United States Patent and Trademark Office

| APPLICATION NO. | FILING DATE | FIRST NAMED INVENTOR | ATTORNEY DOCKET NO. | CONFIRMATION NO. | |
|-----------------------|---------------------------------------|-------------------------|---------------------|------------------|--|
| 10/655,595 | 09/05/2003 | Bernd Christoph Lang | 4398-254 | 7314 | |

| | Application No. | Applicant(s) | | | | |
|---|--|--|--|--|--|--|
| Office Action Summary | Examiner | Art Unit | | | | |

DETAILED ACTION

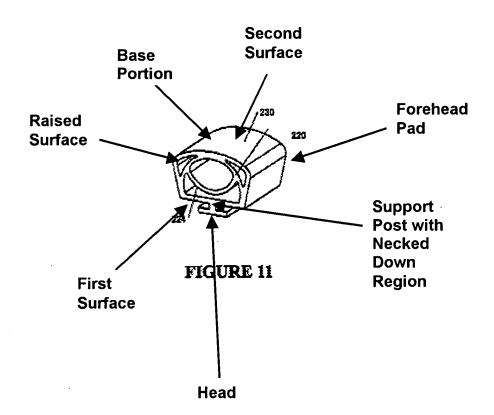
Gradon in a respiratory mask discloses: a base portion (see illustration of Fig. 11 below), wherein the base portion defines a first surface, and a second surface to contact a user's forehead, wherein the second surface is concave (see illustration of Fig. 11

below); a support post, wherein the support post projects from the first surface and comprises a necked down region; and a head adapted to connect the support post to a forehead support of a respiratory mask (Fig. 7).

With respect to claim 2, Gradon discloses wherein the support post projects from the base portion and is integrally molded therewith (See illustration of Fig. 11 above).

With respect to claim 3, Gradon discloses wherein the second surface defines a raised surface pattern to at least one of aid in airflow, prevent sweating, and increase comfort to the user (see illustration of Fig. 11 above; inasmuch as the raised surface compresses and has an opening it meets the limitations of aiding in airflow, preventing sweating and increasing comfort to a user).

With respect to claim 31, Gradon discloses wherein the forehead pad consists of the base portion, the support post, and the head (Figs. 8-11, see illustration of Fig. 11 above).

With respect to claim 33, Gradon discloses a forehead support consisting essentially of a base portion to contact a user's forehead; and a support post connected to a central portion of the base portion (see illustration of Fig. 11 above, MPEP 211.03 the additional elements of Gradon do not materially effect the basic and novel characteristics of the claimed invention).

With respect to claim 34, Gradon discloses wherein the support post is substantially centrally mounted on the base portion (see illustration of Fig. 11 above).
